# Discussion of Maintenance Items 331 and 332

## Revision 1

*IEEE 802.1 TSN TG*  
2021.08.09

# Maintenance Item #331 - 17 (Example 1)

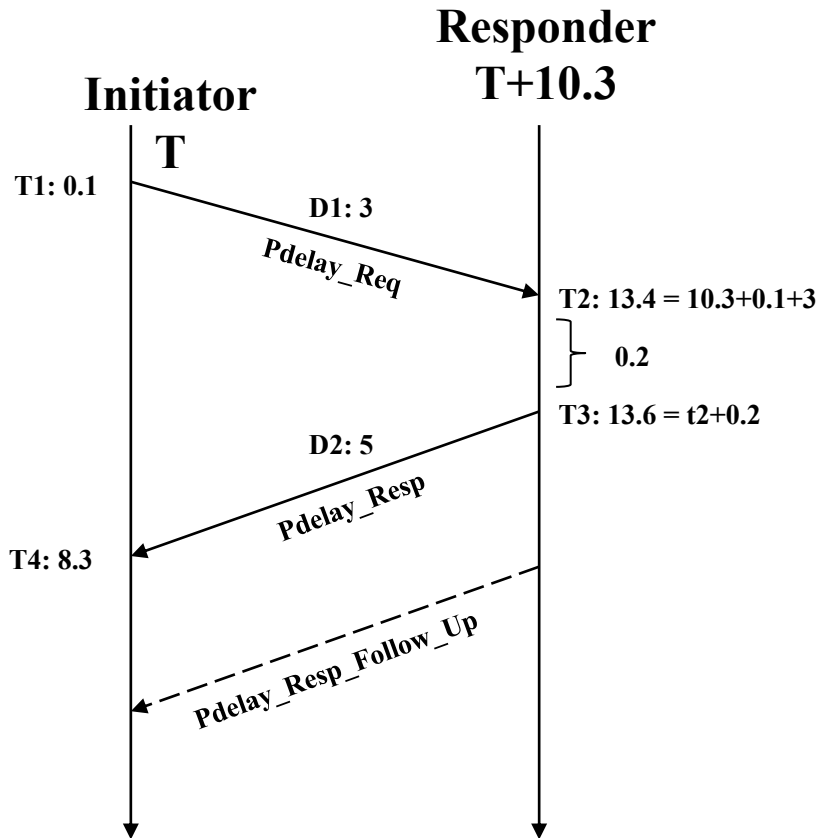
- $\text{delayAsy} = (D2 - D1) / 2 = 1$  (According to Clause 8.3)
- P2P mechanism (published 802.1AS-2020)
  - ①  $\text{Preq\_TS} = 0, \text{Preq\_CF} = 0$  (item b of 11.2.17.2)
  - ②  $\text{Presp\_TS} = 13, \text{Presp\_CF} = 0.4$  (item c of 11.2.17.2)
  - ③  $\text{Presp\_Follow\_TS} = 13, \text{Presp\_Follow\_CF} = 0.6$  (item d of 11.2.17.2)
  - ④ According to 11.2.19.3.4,
    - I.  $t1 = T1 = 0.1$
    - II.  $t2 = \text{Presp\_TS} + \text{Presp\_CF} = 13.4 = T2$
    - III.  $t3 = \text{Presp\_Follow\_TS} + \text{Presp\_Follow\_CF} = 13.6 = T3$
    - IV.  $t4 = T4 = 8.3$
  - ⑤ According to 11.2.19.3.4,

$$\text{MeanLinkDelay} = [(t4-t1) - (t3-t2)]/2 = 4$$
- Common\_P2P mechanism (published 802.1AS-2020)
  - ①  $\text{Preq\_TS} = 0, \text{Preq\_CF} = -\text{delayAsy} = -1$  (item b of 11.2.17.2)
  - ②  $\text{Presp\_TS} = 13, \text{Presp\_CF} = -0.4$  (item c of 11.2.17.2)
  - ③  $\text{Presp\_Follow\_TS} = 13, \text{Presp\_Follow\_CF} = \text{Preq\_CF} + 0.6 = -0.4$  (item d of 11.2.17.2)
  - ④ According to 11.2.19.3.4,
    - I.  $t1 = T1 = 0.1$
    - II.  $t2 = \text{Presp\_TS} - \text{Presp\_CF} = 13.4$  (item e of 11.2.17.2)
    - III.  $t3 = \text{Presp\_Follow\_TS} + \text{Presp\_Follow\_CF} = 12.6$
    - IV.  $t4 = T4 = 8.3$
  - ⑤ According to 11.2.19.3.4,

$$\text{MeanLinkDelay} = [(t4-t1) - (t3-t2)]/2 = 4.5$$

Incorrect

Common P2P mechanism with correction of this presentation

$$\text{III. } t3 = \text{Presp\_Follow\_TS} + \text{Presp\_Follow\_CF} + \text{delayAsy} \\ = 13 - 0.4 + 1 = 13.6$$

$$\text{MeanLinkDelay} = [(8.3 - 0.1) - (13.6 - 13.4)]/2 = 4$$

# Maintenance Item #331 - 18 (Example 2)

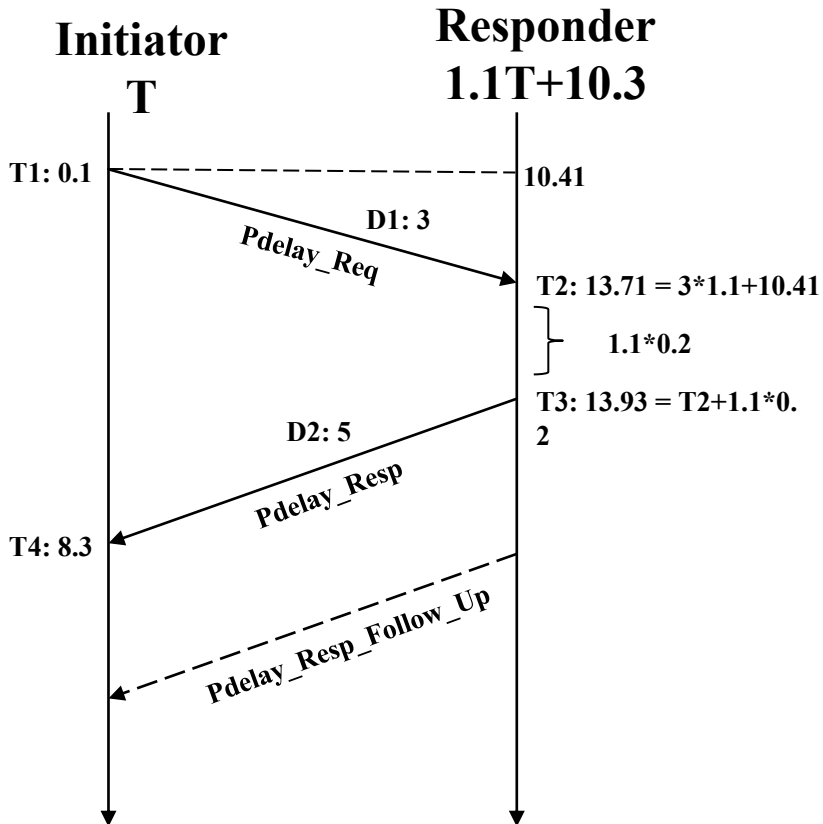
- $\text{delayAsy} = (D2 - D1) / 2 = 1$  (According to Clause 8.3)
  - P2P mechanism (published 802.1AS-2020)
    - ①  $\text{Preq\_TS} = 0, \text{Preq\_CF} = 0$
    - ②  $\text{Presp\_TS} = 13, \text{Presp\_CF} = 0.71$
    - ③  $\text{Presp\_Follow\_TS} = 13, \text{Presp\_Follow\_CF} = 0.93$
    - ④ According to 11.2.19.3.4,
      - I.  $t1 = T1 = 0.1$
      - II.  $t2 = \text{Presp\_TS} + \text{Presp\_CF} = 13.71 = T2$
      - III.  $t3 = \text{Presp\_Follow\_TS} + \text{Presp\_Follow\_CF} = 13.93 = T3$
      - IV.  $t4 = T4 = 8.3$
    - ⑤ According to 11.2.19.3.4

$$\text{meanLinkDelay} = [1.1*(t4-t1) - (t3-t2)]/2 = [1.1*(8.3-0.1) - (13.93-13.71)]/2 = (1.1*8.2 - 0.22)/2 = (9.02-0.22)/2 = 4.4$$
- Correct
- Common\_P2P mechanism (published 802.1AS-2020)
    - ①  $\text{Preq\_TS} = 0, \text{Preq\_CF} = -\text{delayAsy} = -1$
    - ②  $\text{Presp\_TS} = 13, \text{Presp\_CF} = -0.71$
    - ③  $\text{Presp\_Follow\_TS} = 13, \text{Presp\_Follow\_CF} = \text{Preq\_CF} + 0.93 = -0.07$
    - ④ According to 11.2.19.3.4,
      - I.  $t1 = T1 = 0.1$
      - II.  $t2 = \text{Presp\_TS} - \text{Presp\_CF} = 13.71$
      - III.  $t3 = \text{Presp\_Follow\_TS} + \text{Presp\_Follow\_CF} = 12.93$
      - IV.  $t4 = T4 = 8.3$
    - ⑤ According to 11.2.19.3.4

$$\text{meanLinkDelay} = [1.1*(t4-t1) - (t3-t2)]/2 = [1.1*(8.3-0.1) - (12.93-13.71)]/2 = (1.1*8.2 + 0.78)/2 = (9.02+0.78)/2 = 4.9$$
- Incorrect
- Common P2P mechanism with correction of this presentation
- III.  $t3 = \text{Presp\_Follow\_TS} + \text{Presp\_Follow\_CF} + \text{delayAsy} = 13 - 0.07 + 1 = 13.93$
- $\text{MeanLinkDelay} = [1.1(8.3 - 0.1) - (13.93 - 13.71)]/2 = 4.4$
- Correct

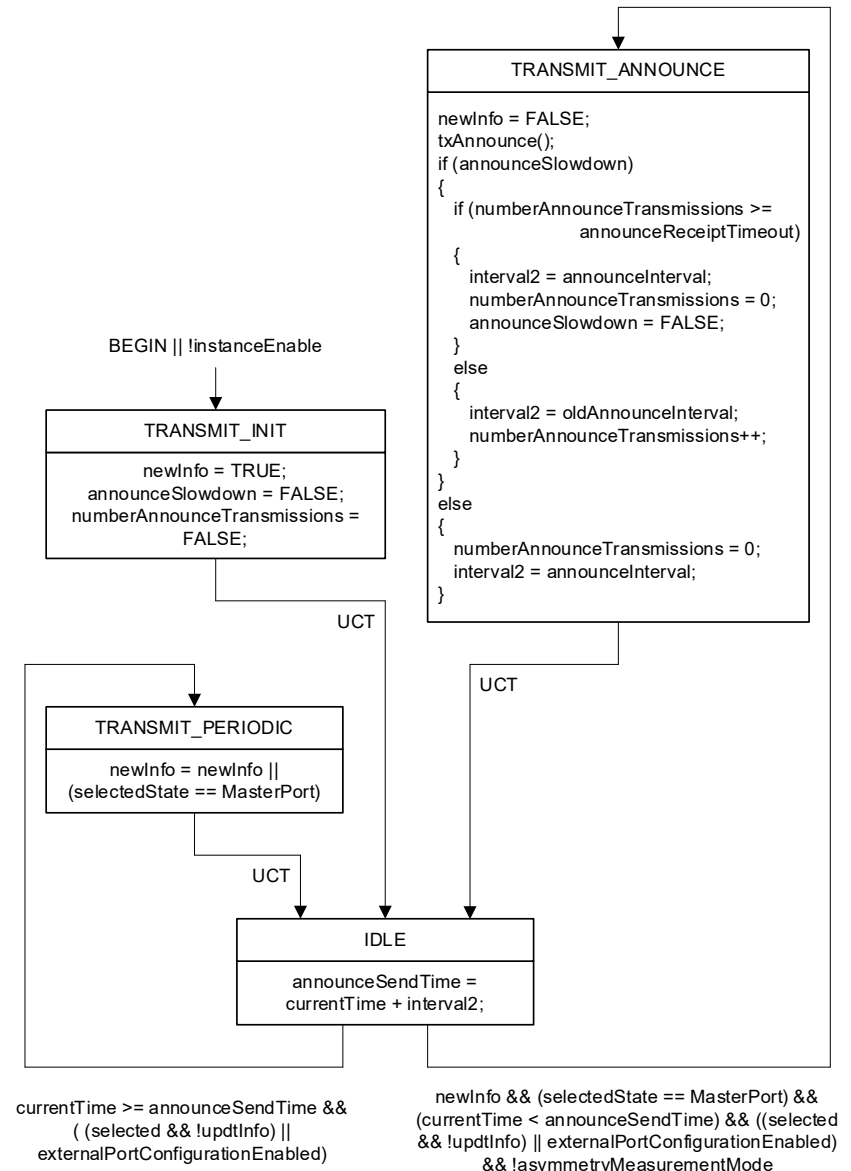
NOTE 1—The mean propagation time is divided by neighborRateRatio to convert it from the time base of the PTP Instance at the other end of the attached PTP Link to the time base of the current PTP Instance. ~~If the instance-specific peer-to-peer delay mechanism is used (i.e., portDS.delayMechanism is P2P),~~ The quantity delayAsymmetry is divided by rateRatio to convert it from the time base of the Grandmaster Clock to the time base of the current PTP Instance. ~~The first~~ These two quotients ~~is~~ are then subtracted from syncEventIngressTimestamp, ~~and the second quotient is subtracted from syncEventIngressTimestamp if the instance-specific peer-to-peer delay mechanism is used.~~ The syncEventIngressTimestamp is measured relative to the time base of the current PTP Instance. See 11.2.17.2 for more detail.

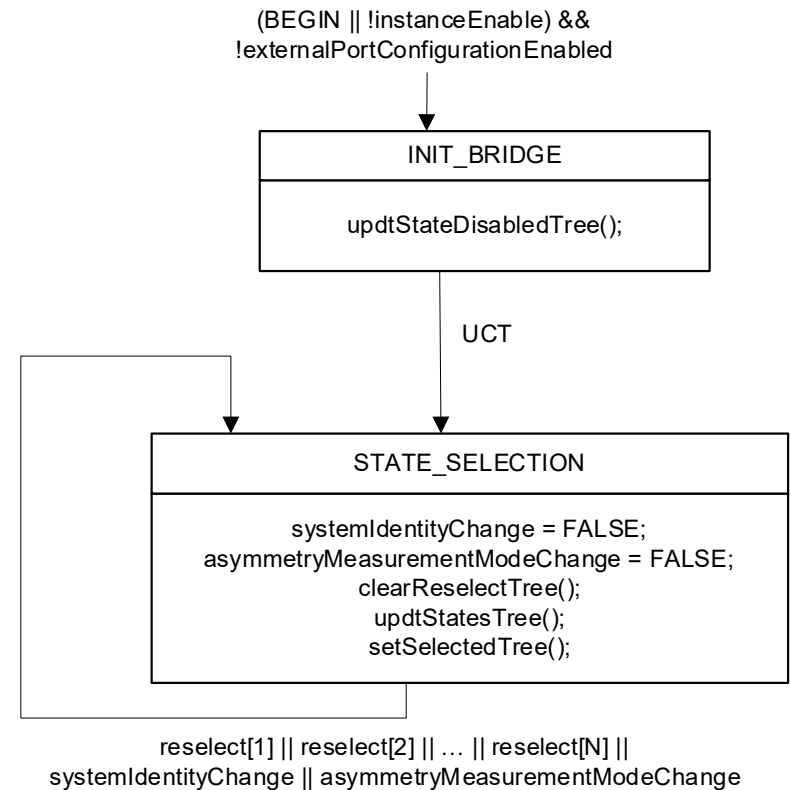
- An Announce message is transmitted by the PortAnnounceTransmit state machine when the global variable newInfo is set to TRUE
- From the IDLE state, if newInfo is TRUE and selectedState is MasterPort (and currentTime is not yet announceSendTime), the right branch is taken and an Announce message is sent

- ❑ In the case of BMCA, `newInfo` is set to `TRUE` as a result of actions by the `PortStateSelection` state machine (via the function `updtStatesTree()`, see 10.3.13.2.4) and the `PortAnnounceInformation` state machine
- ❑ `updtStatesTree()` is invoked when `reselect[j]` becomes `TRUE` for any port `j` (i.e., the triggering of the BMCA)
  - This could occur, e.g., due to receipt of an Announce message (see the `PortAnnounceInformation` state machine in 10.3.12 and on the next slide)

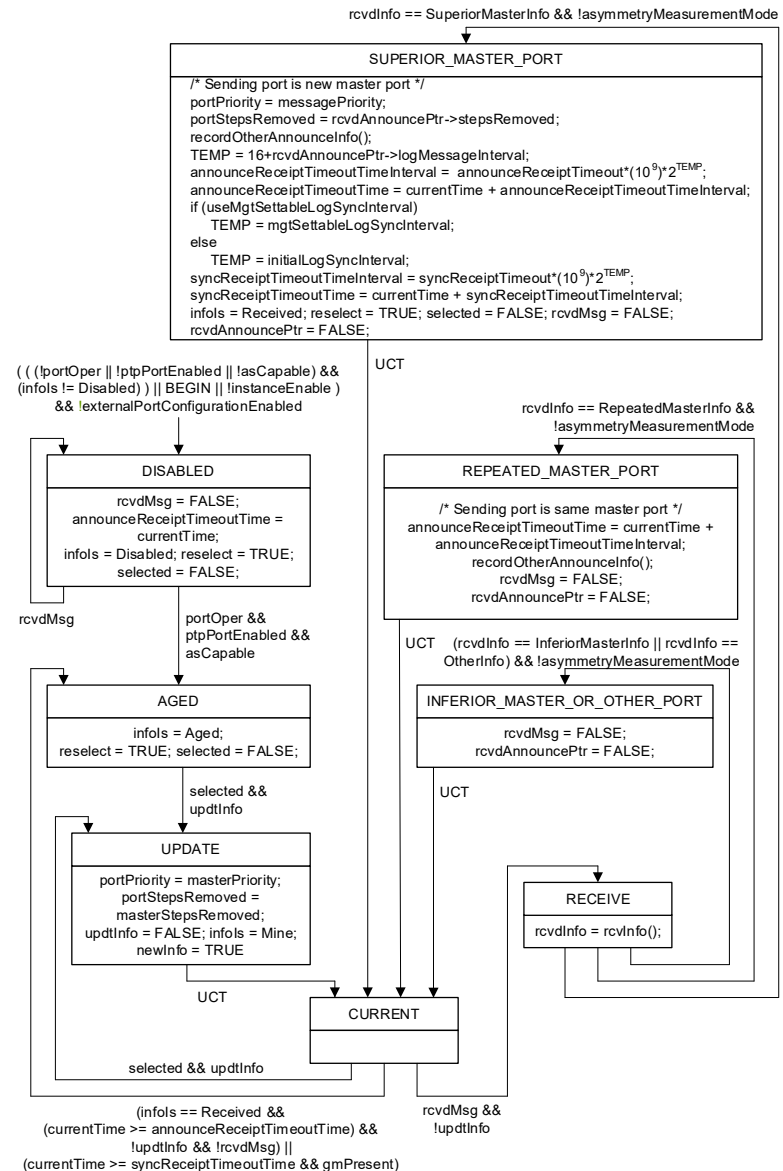
□ updtStatesTree() determines the port state in item f) of 10.3.13.2.4; in f)3), f)4), and f)8) of 10.3.13.2.4, the port state is set to MasterPort and the variable updtInfo is set to TRUE

□ This in turn causes the PortAnnounceInformation state machine to transition from the CURRENT state to the UPDATE state, which in turn sets updtInfo to FALSE and newInfo to TRUE

- As indicated two slides previously, this causes the PortAnnounceTransmit state machine to transmit an Announce message

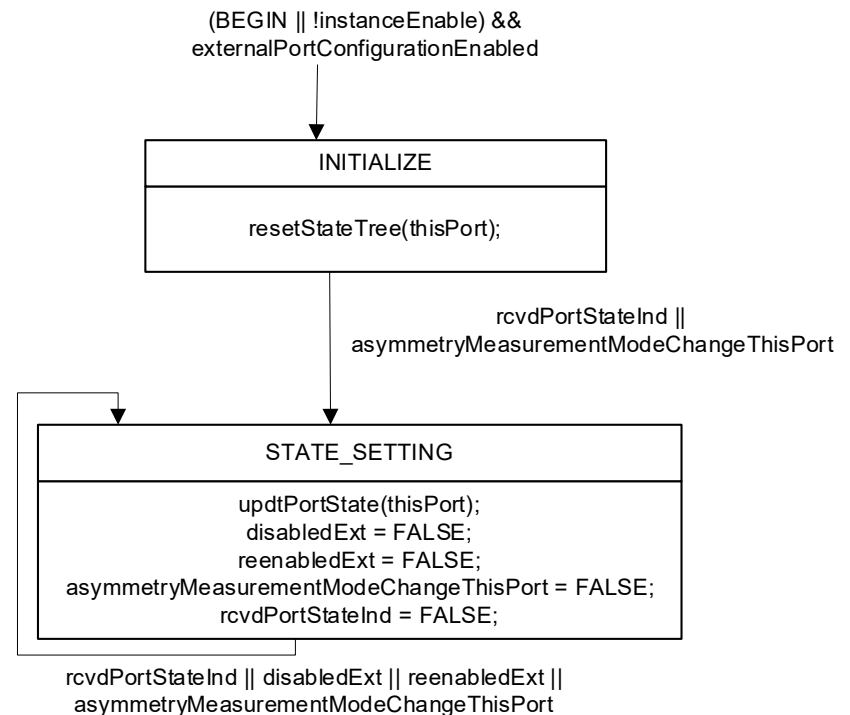
- ❑ In the published 802.1AS-2020, when external port configuration is used newInfo is not set to TRUE, and an Announce message is not immediately sent
- ❑ In external port configuration, the port state is set by the function updtPortState(thisPort) in the PortStateSettingExt state machine

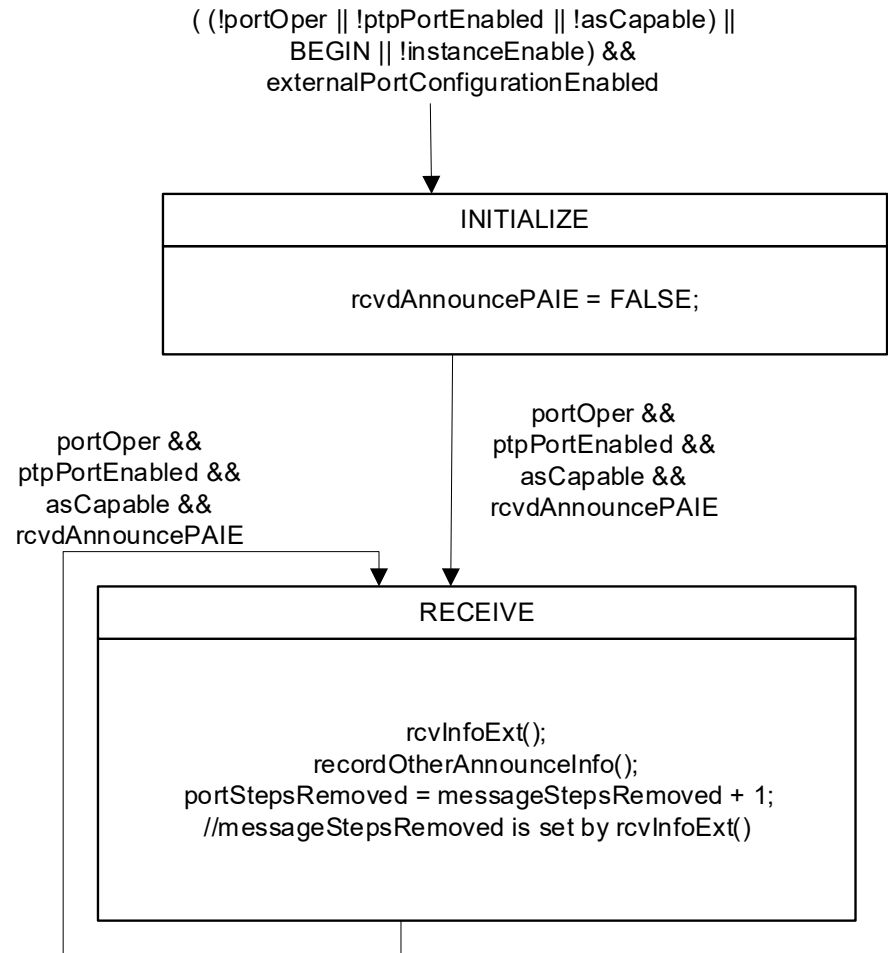
- ❑ In external port configuration, the PortAnnounceInformation state machine is not invoked because the BMCA is not triggered by receipt of an Announce message
  - Instead, the PortAnnounceInformationExt state machine is invoked, which simply records information contained in the Announce message (e.g., time properties information)
- ❑ The problem can be fixed by setting newInfo to TRUE in item c)3) of updtPortState(j), where the port state is set

- ❑ Add the following sentence to item c)3) of the updtPortState(j) function (see 10.3.15.2.2): If portStateInd is equal to MasterPort, set newInfo to TRUE. Item c)3) then reads:
  - 3) selectedState[j] is set to portStateInd. If portStateInd is equal to MasterPort, set newInfo to TRUE.
- ❑ In Figure 10-12, remove the variable newInfo from the arrow going from the PortAnnounceInformationExt block to the PortAnnounceTransmit block (note that newInfo is not set by the PortAnnounceInformationExt block)
- ❑ In Figure 10-12, add the variable newInfo to the arrow going from the PortStateSetting block to the PortAnnounceTransmit block
